**TOWN OF LEESBURG
TOWN COUNCIL WORK SESSION**

Subject: Referral Request from Loudoun County on ZMAP 2012-0011, Tuscarora Crossing **4th SUBMISSION**

RE: Referral Request for ZMAP 2012-0011, Tuscarora Crossing, 4th Submission
(reviewed by Town staff)

RE: TLCR-2012-0006
TUSCARORA CROSSING
ZMAP FIFTH SUBMISSION
REFERRAL COMMENTS

CONCEPT DEVELOPMENT PLAN
TUSCARORA CROSSING
ZONING MAP AMENDMENT
ZMAP 2012-0011
CATOCIN ELECTION DISTRICT LOUDOUN COUNTY, VIRGINIA

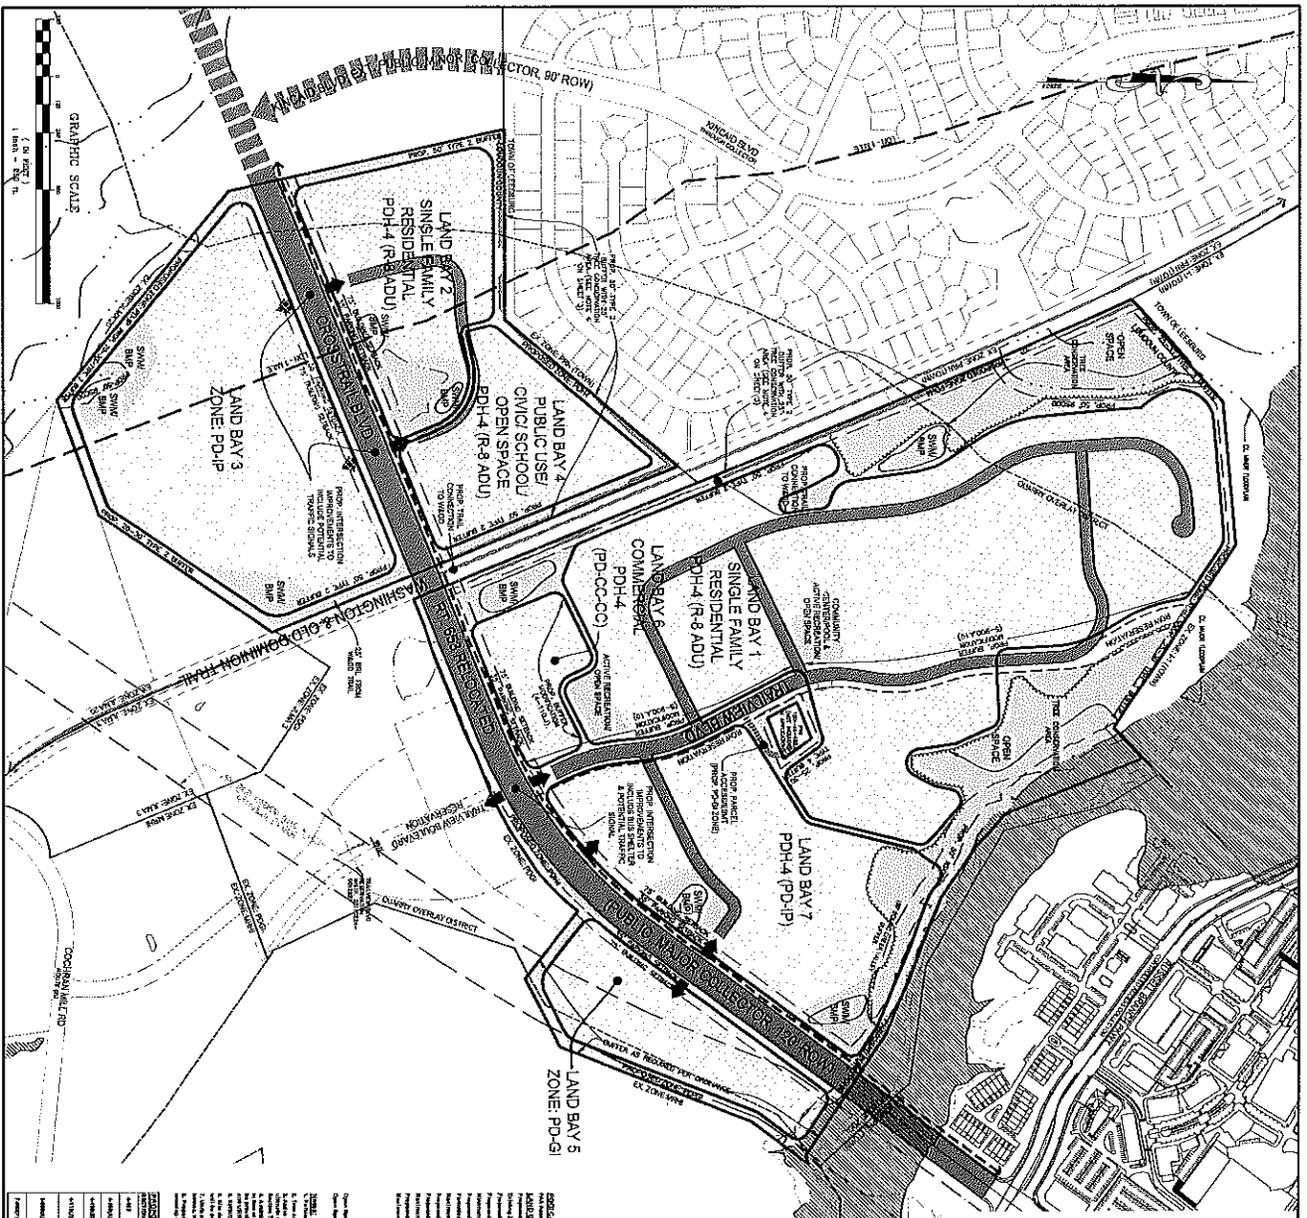
1. Utility Provision – Note 11 on the Plan set states: “The site will be supplied with public water and sanitary sewer by extension of existing systems.” It does not state specifically that utilities will be provided by the Town. Notes 13 and 18 also state that construction will be subject to Loudoun Water standards.
Note 11 should be revised to state: “The site will be supplied with public water and sanitary sewer by extension of existing systems as approved by the Town of Leesburg Town Council.”

2. Square Footage Inconsistency – The total square footage proposal for office and light industrial on the tabulations on Sheet 1 and Proffer II.D. 2 for Land Bay 7 do not correspond with the square footage counts on sheet 7 of the plan set.
Please clarify.

The proffers state that the applicant will pay for the cost of providing water and sewer to the site. However, there is still no detail provided for how the site will be served. The applicant should depict how each of the land bays will be served with water service. Water loops should be accomplished for service reliability and safety. Provision of one connection point to the water system will not satisfy this requirement. Utility system design at this stage of development needs to provide reasonable assurance to the Town that the applicant has a workable plan for utility service. The Town still has no such assurance with this third submission. This continues to be an issue with the 4th submission. The proposed water pipe sizes and depicted alignments shown on Sheet 7 should be removed because the alignments and sizes have not been substantiated by design.

or multimodal related facilities, and other transportation improvements.” *The Concept Development Plan is still deficient in showing all “external and internal traffic ways, including existing and proposed rights-of-way, travel lanes, major pedestrian and bike paths and trails, school bus stops/shelters, park and ride lots, and other transit or multimodal related facilities, and other transportation improvements.”*

With the 4th submission Staff continues to request that Trailview Blvd. be constructed to a public street standard for the entire length possible. As currently shown, the proposed roadway appears to be a 4-lane divided roadway section to the FAA parcel and then narrows beyond that point. The four lane divided section should be extended along the alignment of Trailview Blvd. to a cul-de-sac provided at the terminus, which would allow for extension across Tuscarora Creek in the future. Please note that intersection spacing/crossovers will need to meet VDOT design requirements. Also note that the proffer language still lists 70’ ROW, but 90’ of ROW is required for construction of the proposed roadway section. Note also that there appears to be a significant amount of residential development proposed with access via Trailview Blvd. with only one point of access from Crosstrail Blvd. Loudoun County Fire and Rescue personnel should evaluate emergency access within this landbay.

6. Explain the labeling of Crosstrail Blvd. as “Rt. 653 Relocated” on the ZMAP. (Sht. 3). *Note that Crosstrail Blvd. is a planned “major arterial” roadway and not a “collector” street as currently represented on the Concept Development Plan. The application does not address the construction phasing of the portions of Crosstrail Boulevard that this project proposes to construct, including the bridge over the Tuscarora Creek that will complete Crosstrail Boulevard to Russell Branch Parkway. This portion of Crosstrail Boulevard is located almost entirely on the Applicant’s property (with only a minor offsite portion at the Village at Leesburg where all ROW has already been dedicated). The Town of Leesburg is extremely concerned that if the applicant does not construct all four lanes, the traffic from this development will be diverted to existing town roads*
